City of Sanibel

ADDENDUM NO. 1
November 25, 2025

RE: City Hall Finance & IT Wing HVAC Replacement Project(ITB-PW-2-2026/SK) Proposal due date: December 4, 2025 at 2:30pm

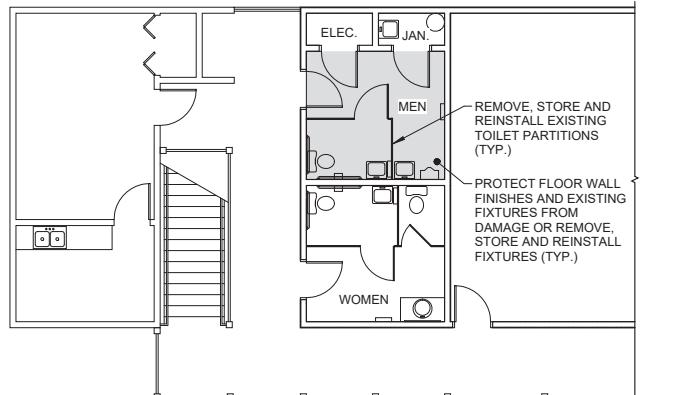
Question No. 4: General key notes(#18) states that metal ductwork shall be fabricated, supported and installed, but in the mechanical keynotes(#1) states that the existing ductwork to remain and reused. Are we reusing the existing ductwork for CU-AHU1/CU-AHU2 or demoing it out and replacing with new?

Response No. 4: It is expected that minor ductwork repairs and replacement will be needed for the HVAC replacements, but generally the existing ductwork and distribution is to remain.

Drawing Title:
**IT/ FINANCE DEPT. WING
PARTIAL PLAN &
REFLECTED CEILING**

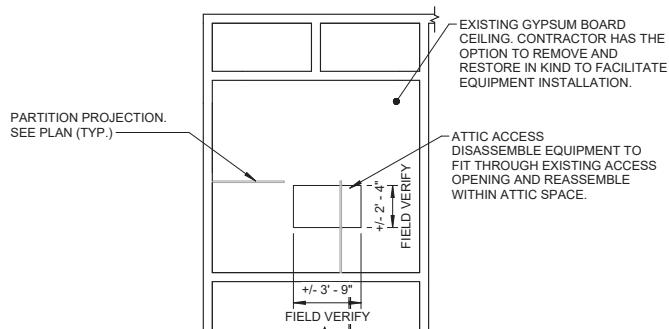
Question No. 6: It talks about removing and replacing the bathroom ceiling. Is this demoing the entire ceiling? If so, are we going back with hard ceiling or ceiling grid?

Response No. 6: Contractor has the option to remove and restore in kind the existing ceiling to facilitate equipment installation. See attached drawing sheet A1.
